Planning Commission Vote Report

Location: 18325 Wings Corporate Drive

Description: P.Z. 05-2023 Wings Corporate Estates, Lot 5 (Wings & Wheels of Chesterfield LLC): A request to rezone an existing "PI" Planned Industrial District to a new "PI" Planned Industrial District for a 1.3-acre tract of land located northeast of the intersection of Wings Corporate Drive and Buzz Westfall Drive (17W120087).

RE: Wings Corporate Estates, Lot 5 (Wings & Wheels of Chesterfield, LLC)

PRELIMINARY DEVELOPMENT PLAN

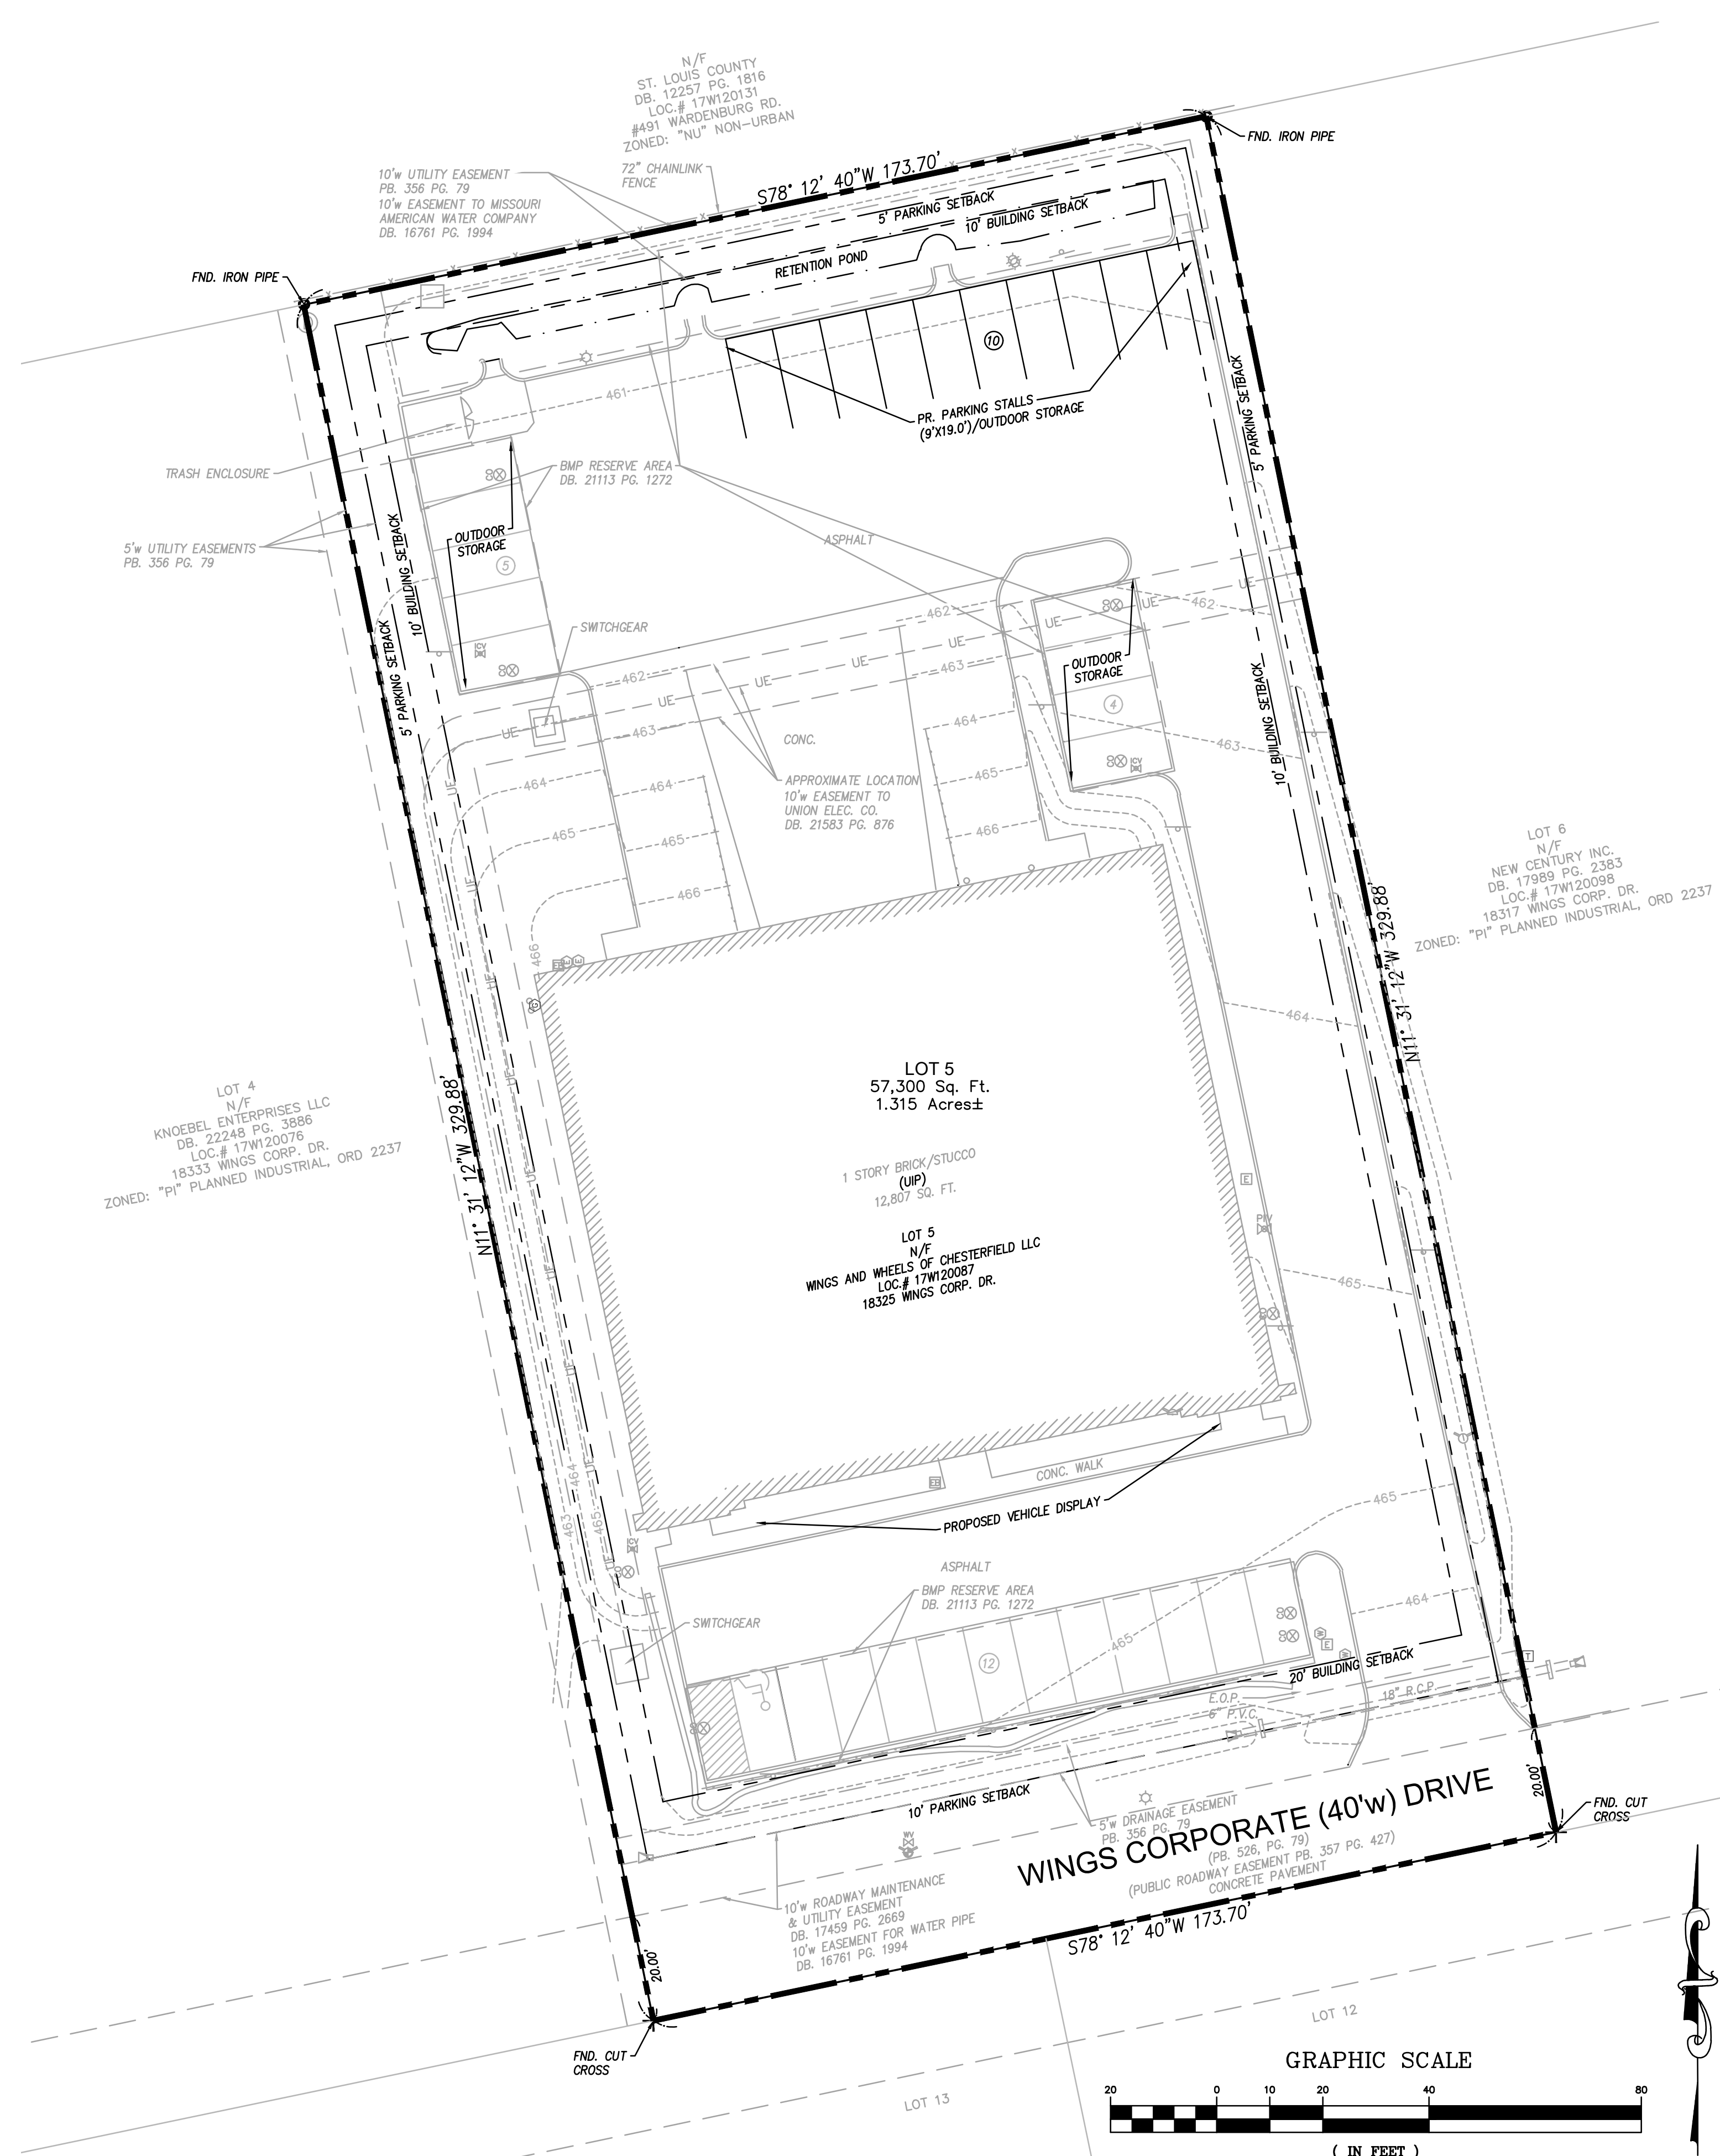
- 3) The topic of outdoor storage and display was discussed. Provide a response detailing the property owner's plans for storage and display for the site. If areas of outdoor storage or display are desired, they need to be delineated on the preliminary development plan.

- 4) The existing entrance is gated. The gate is not shown on the ALTA Survey or Preliminary Development Plan. The existing gated entrance was not previously approved by the City and does not appear to meet City requirements for a minimum 60-foot stacking length nor include provisions for a rejected vehicle to turn around. Please provide information on how this issue will be addressed. Requirements for a gated entrance can be found in [City Code § 405.04.100\(D\)\(6\)](#), Driveway Access Location and Design Standards.

- 5) The existing site is fenced. The fence is not shown on the ALTA Survey or Preliminary Development Plan. The fence was not previously approved by the City. The fence would need to be removed or be reviewed/approved under the appropriate Site Development Section Plan approval process. Occupancy will not be released until the site has been brought into compliance.
- 6) Revise the property description to correct the following error highlighted in yellow below:

- 7) Delete "General Notes" #8. There are no regulatory floodplain or CVSWMP features on Lot 5.

Applicant Response: Please see Preliminary Development Plan for areas delineated as “outdoor storage” and “display”. The vehicle display area will be along the front (south face) of the existing building. Display vehicles will be returned inside at the end of each business day. Outdoor Storage will be located in the rear of the site (north of the existing building) and comply with the City’s requirements for screening.

Applicant Response: The Alta Survey was performed before the gate was installed by the previous owner. Wings & Wheels of Chesterfield, LLC, was unaware that the existing gated entrance was not approved by the City of Chesterfield. A Site Development Section Plan will be filed with the City upon completion of the rezoning process depicting a revised location of the entrance gate. Revised entrance gate location will be in accordance with City’s requirements for a gated entrance as defined in the Unified Development Code.

Applicant Response: The Alta Survey was performed before the fence was installed by the previous owner. Wings & Wheels of Chesterfield, LLC, was unaware that the existing fence was not approved by the City of Chesterfield. A Site Development Section Plan will be filed with the City upon the completion of the rezoning process depicting the existing fence.

Applicant Response: The property description on the Preliminary Development Plan has been revised to correct the error in the “township”.

Applicant Response: General Notes #8 has been removed from the Preliminary Development Plan.
